ADDENDUM NO. 4

May 6, 2025

This Addendum contains changes to the requirements of the Contract Documents and Specifications. Such changes are to be incorporated into the Construction Documents and shall apply to the work with the same meaning and force as if they had been included in the original document. Wherever this Addendum modifies a portion of a paragraph of the specifications or a portion of any Drawing, the remainder of the Paragraph or Drawing shall remain in force.

**RENOVATE 2ND - 5TH FLOOR
AT KING-SHAW HALL**

04 REFLECTED CEILING PLAN - FOURTH FLOOR
SCALE: 1/8" = 1'-0"

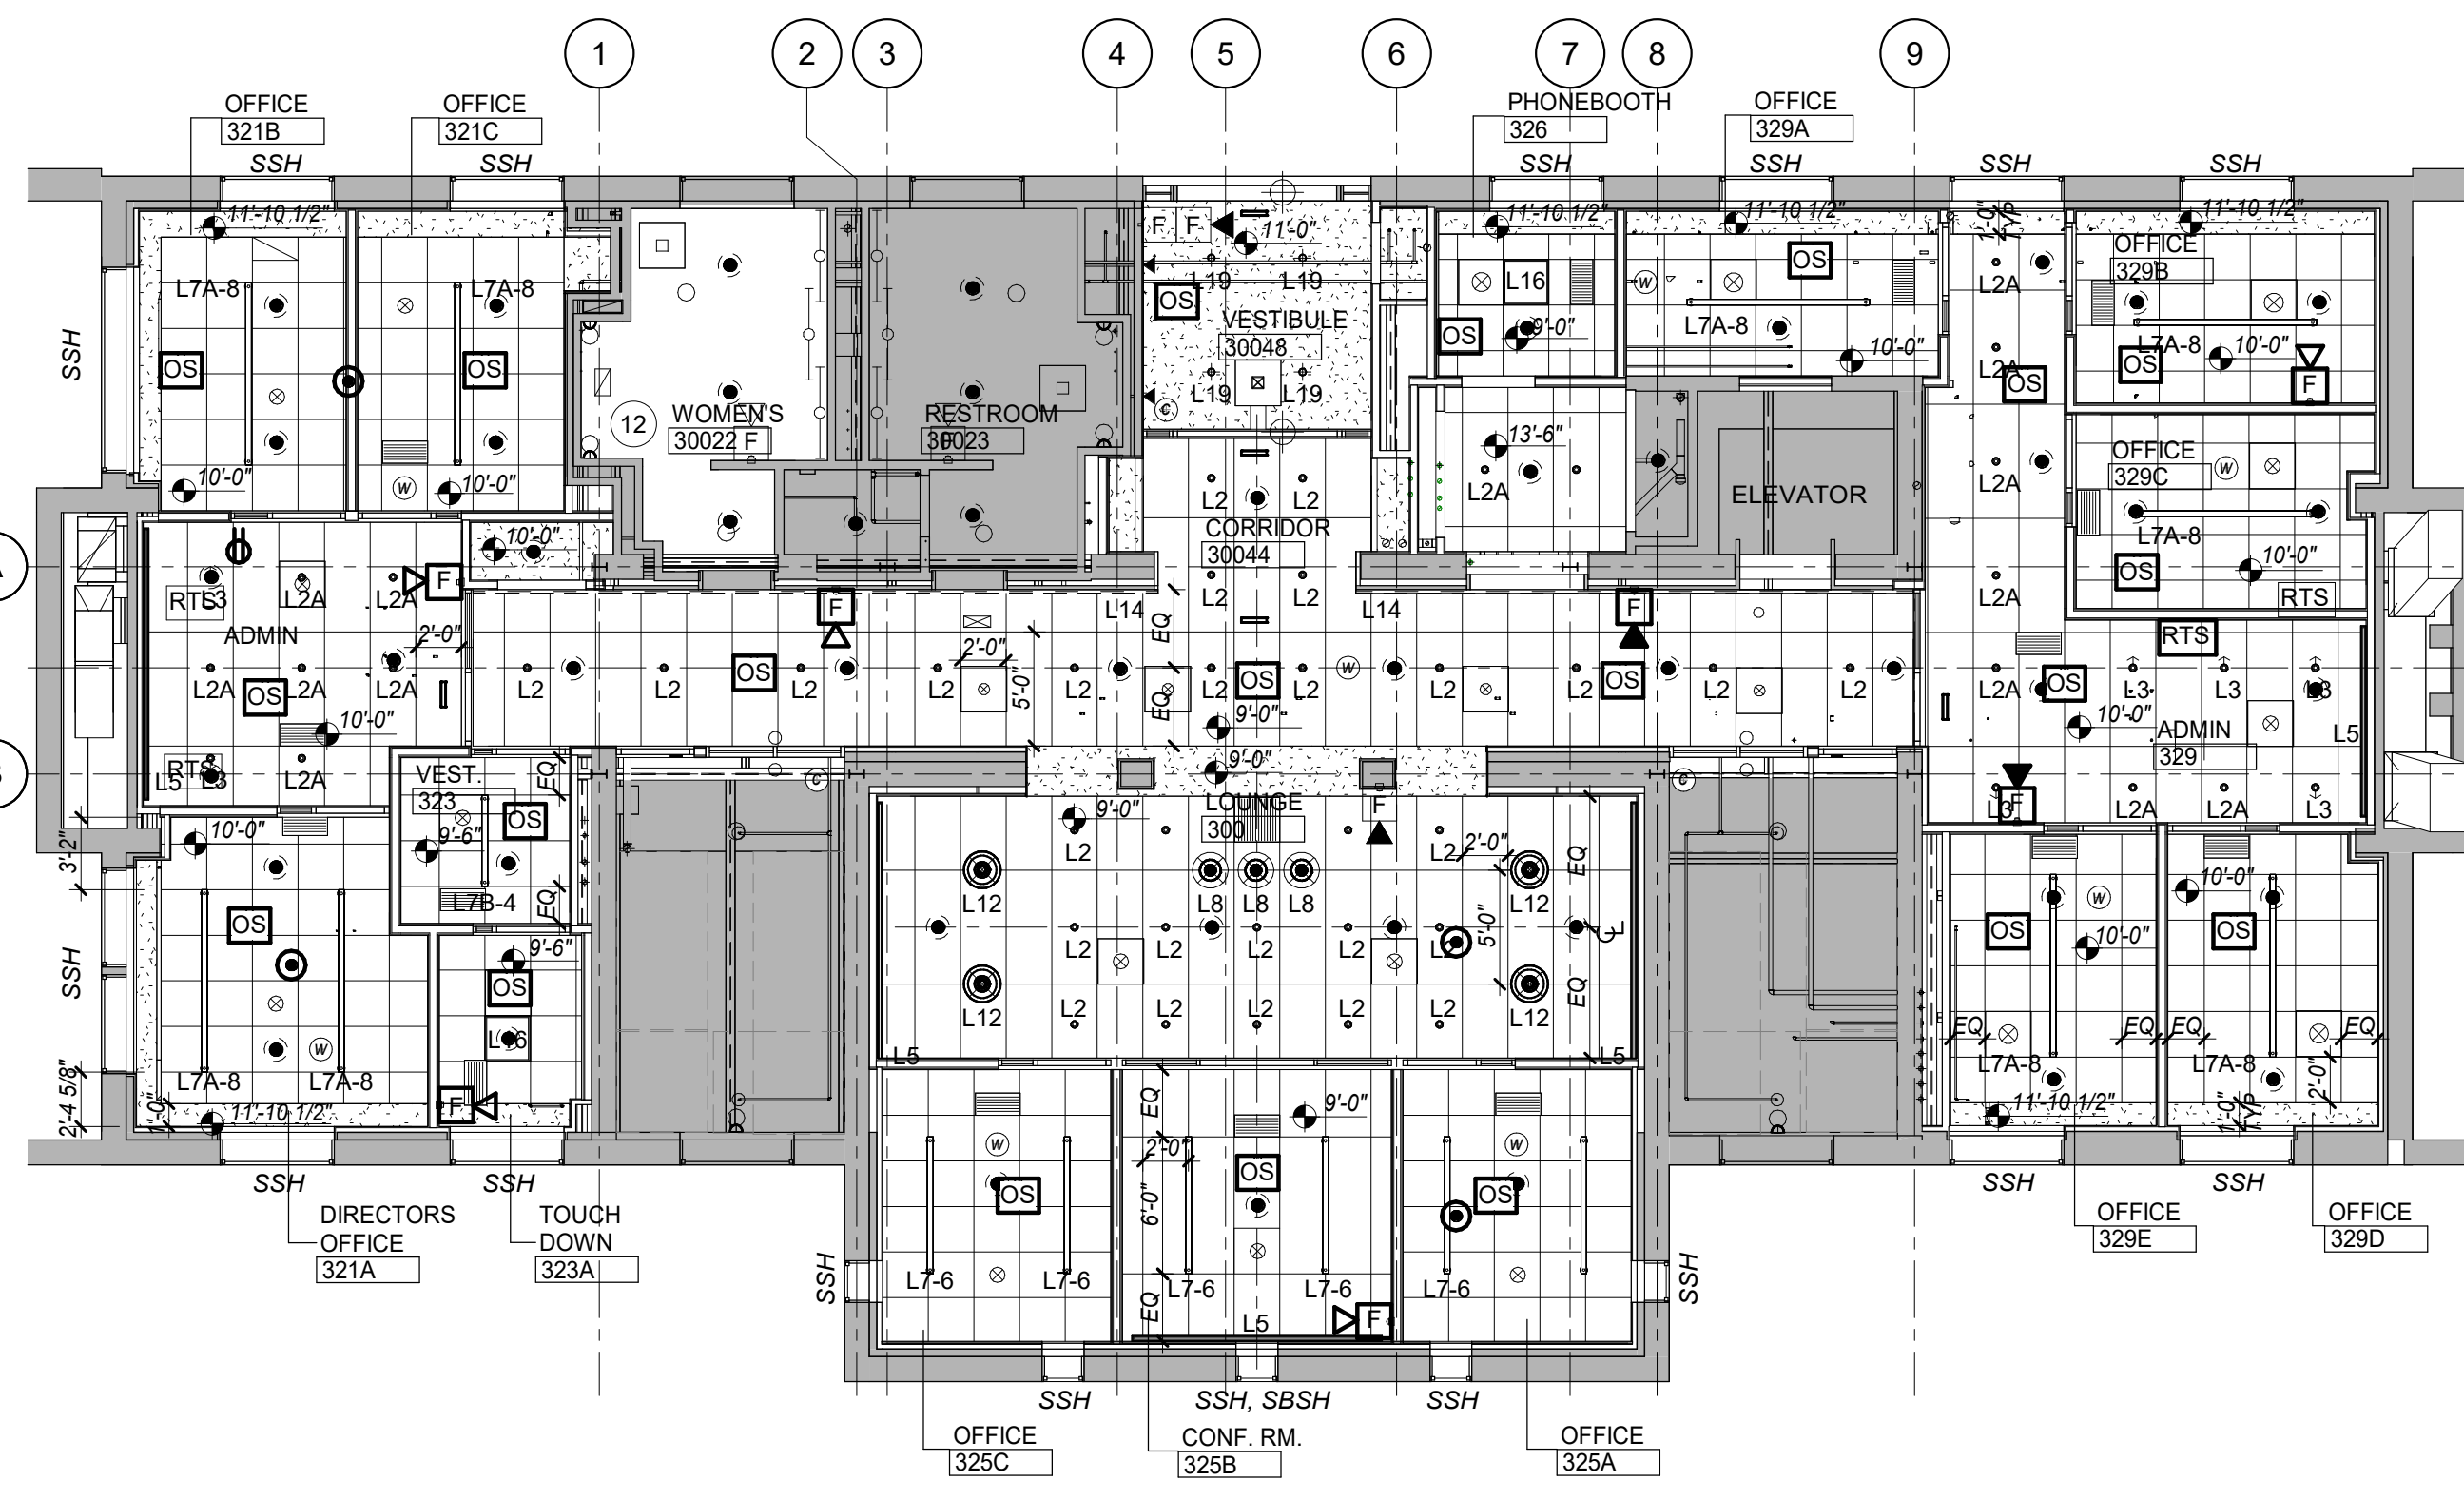
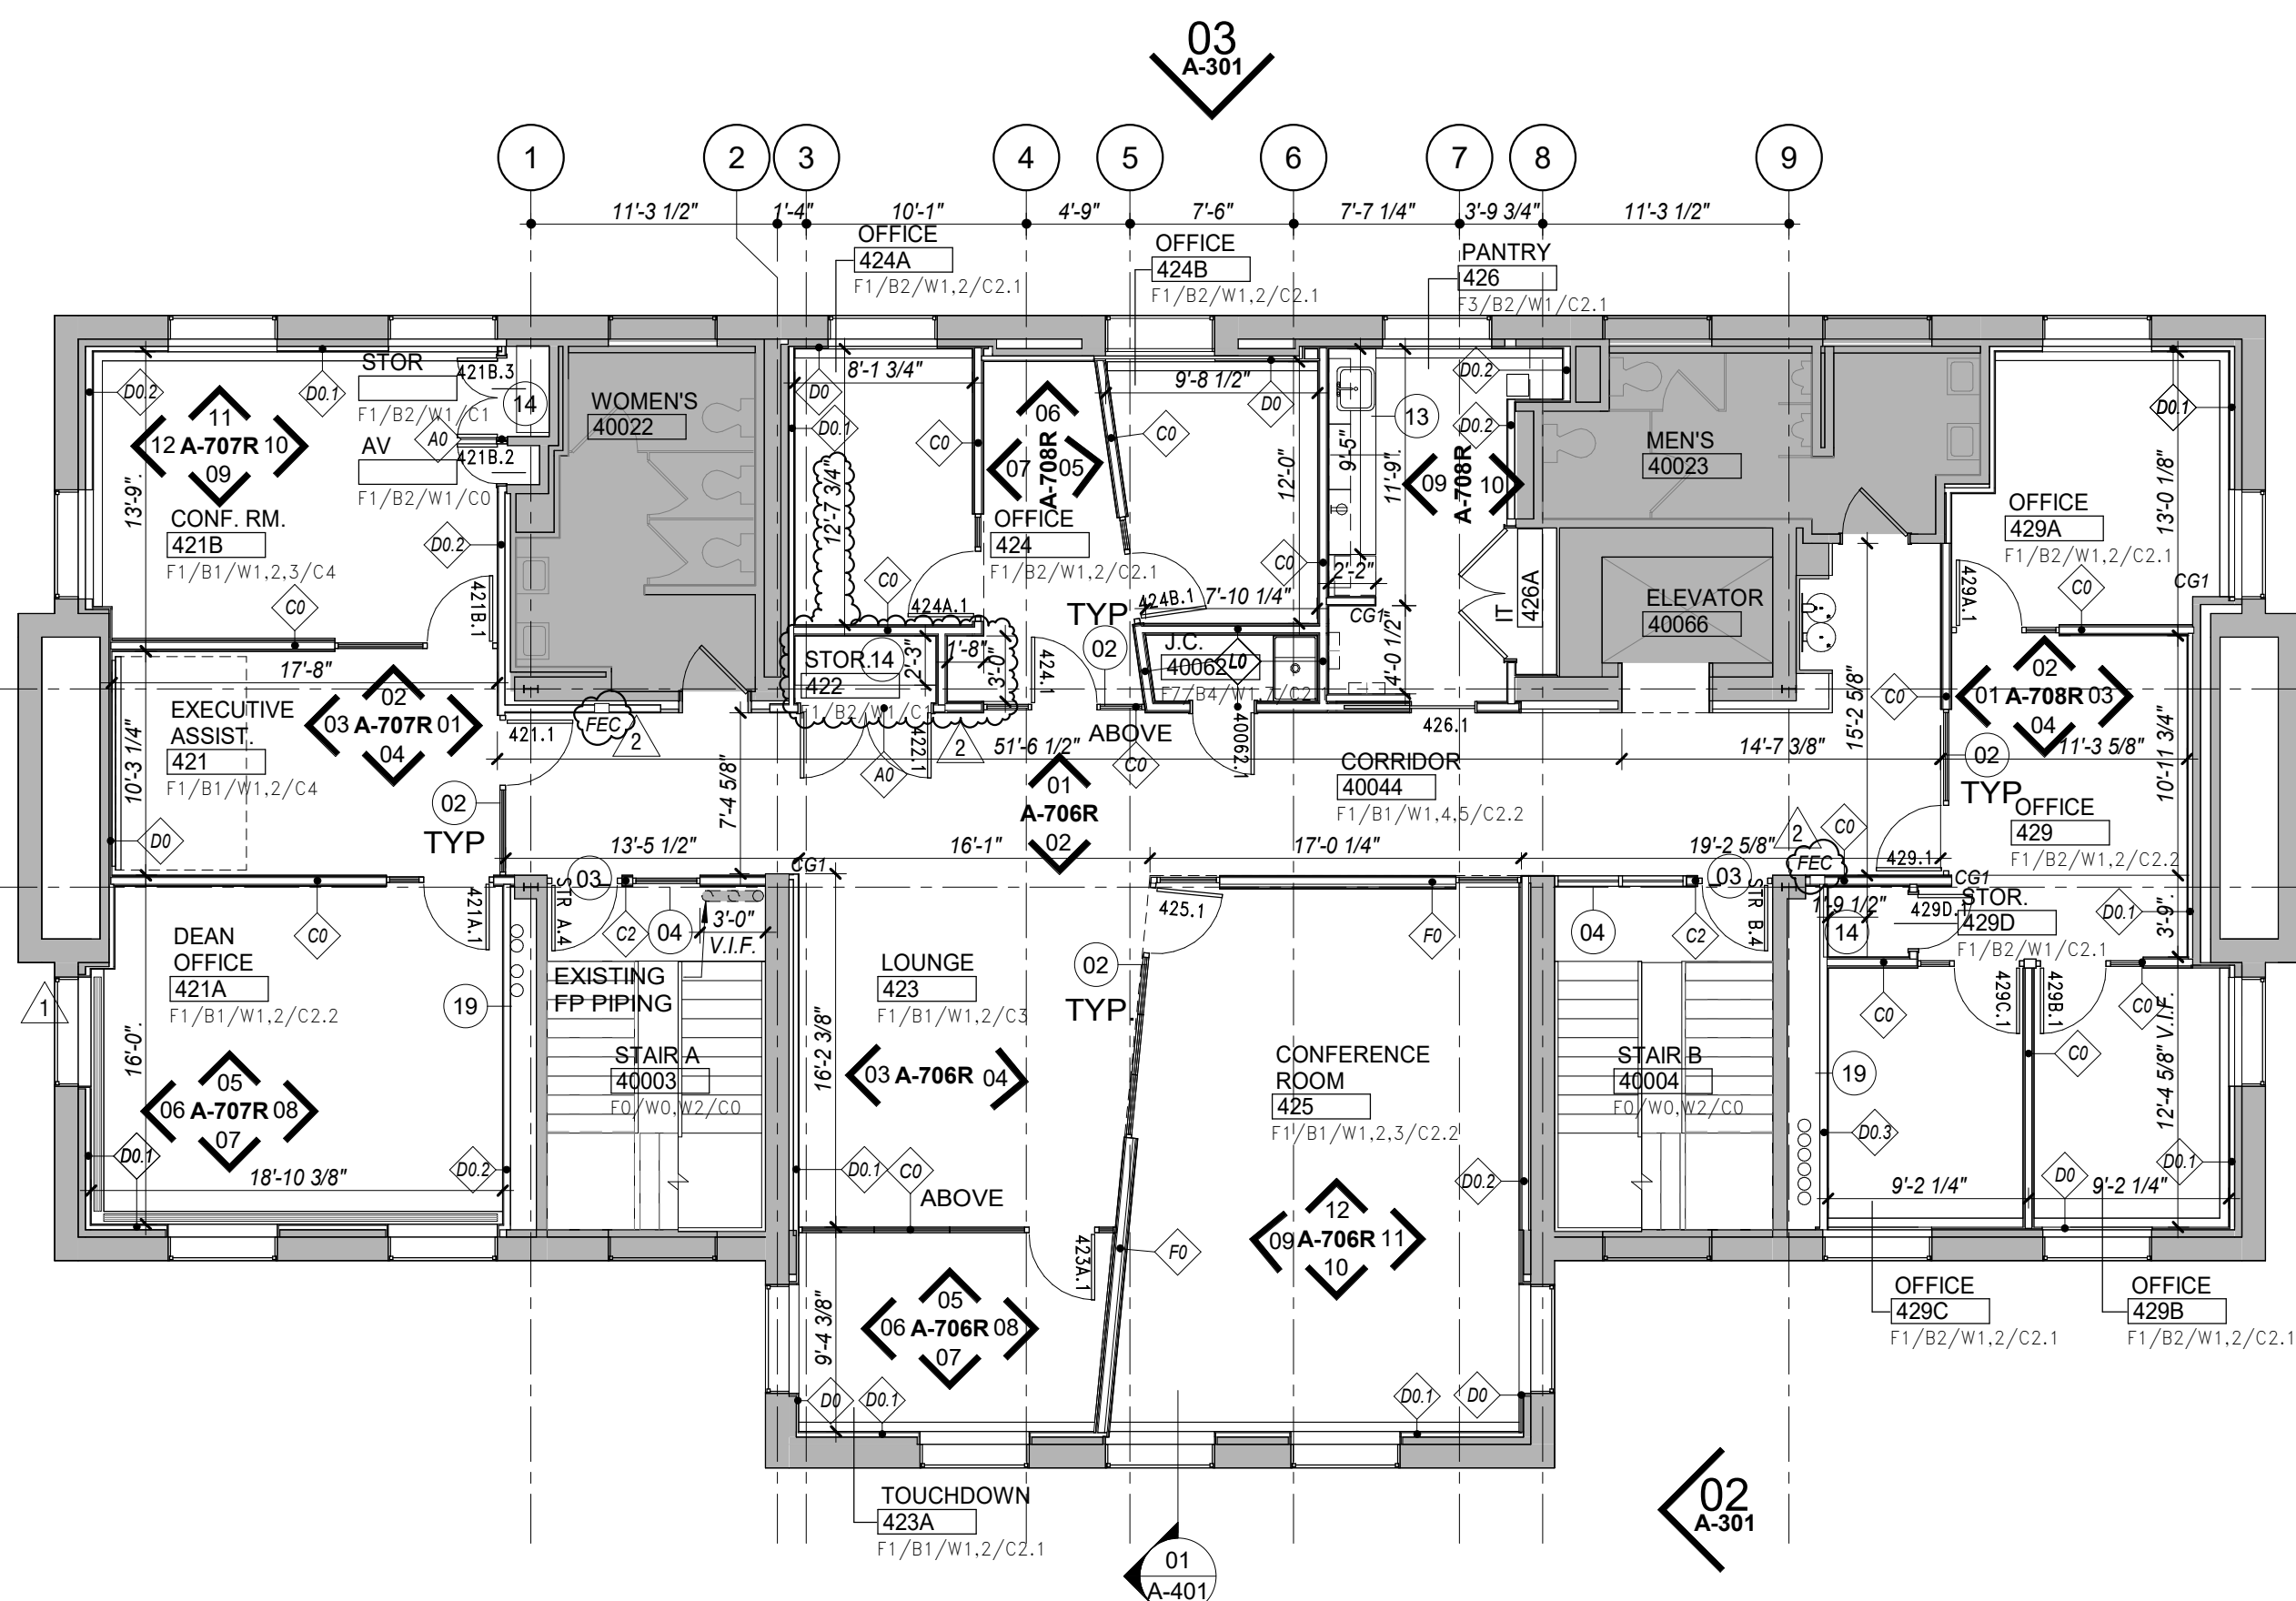
RFI/ Response Index	Page/ Dwg./Spec./Rep. Number	Section/ Paragraph/Topic	RFI	Design Team Response
26	104416	Fire Extinguisher Cabinets	Could not find any FEC shown on the drawings. There is a specification. Please clarify.	See Addendum No. 4 and revised Floor Plans locating FECs.
27	A-750	Signage	Drawing A-750 calls for vinyl signage at details 2, 3 and 5. Please update specification 101400 Signage with information regarding the vinyl signage. Also, these are called out at various interior elevations but the notes tell us to reference A-750. Sometimes it is quite clear what sign is desired but other times it is not. Can the interior elevation notes be updated to add which specific detail on A-750? This will help our signage vendors to provide the most accurate pricing possible.	Signage scope to be confirmed with Owner. See notes at detail 05 on Drawing A-750 for current scope information.
28	A-740	OFCI Items	Please reference A-740. The finish schedule calls for the Composite Paneling that is specified in section 068300 as OFCI. The specification does not indicate that this product is OFCI. Please clarify who is to be providing this product. Same question for items UF1 & UF2. All of the fabric items within specification 098413 Acoustic Panel Fabric are listed as OFCI as well. Please confirm who is to be providing these products.	Composite Paneling, UF1, UF2, and acoustic panel fabrics are Owner-Furnished, Contractor-Installed.
